Re: ESA § 7 Consultation with Nuclear Regulatory Commission on Entergy's Pilgrim Nuclear Power Station, Plymouth, Massachusetts

2006 NRC Staff Biological Assessment

Figure 3. Average NARWC Whale Data (All Months, 1978-2010) from Industrial Economics, North Atlantic Right Whale Consortium Whale Data (1978-2010) as prepared for NMFS 1.25.2011

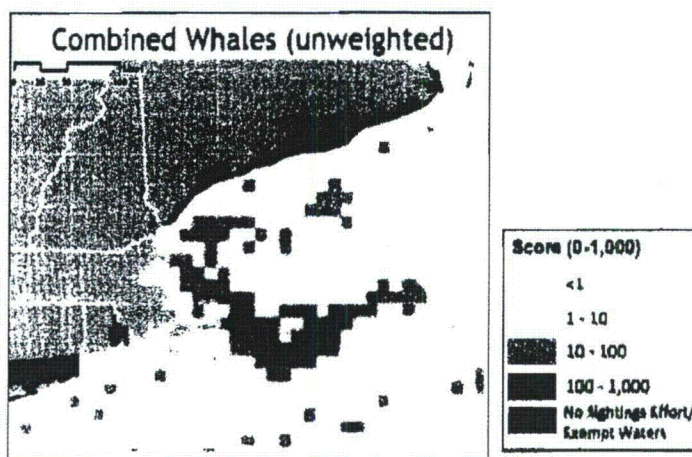
NMFS should consider the fact that the mysticete species mentioned in this quote are not “migrating past” the coast of Massachusetts but remain resident in these waters for much of the year. In addition, some species, like NA right whales, can be found off the coast of Massachusetts year round (Figure 3). This further highlights the need for a geographic definition of the “action area.” Instead of identifying the “action area” with geographic boundaries, the NRC staff BA seems to have accepted Entergy’s early verbiage in its relicensing application Environment Report which talks about whether the species are “in the vicinity of PNPS” for ESA § 7 purposes. “In the vicinity” is a phrase that has little utility for an effort to determine whether PNPS relicensing is likely to adversely affect endangered species and critical habitat.
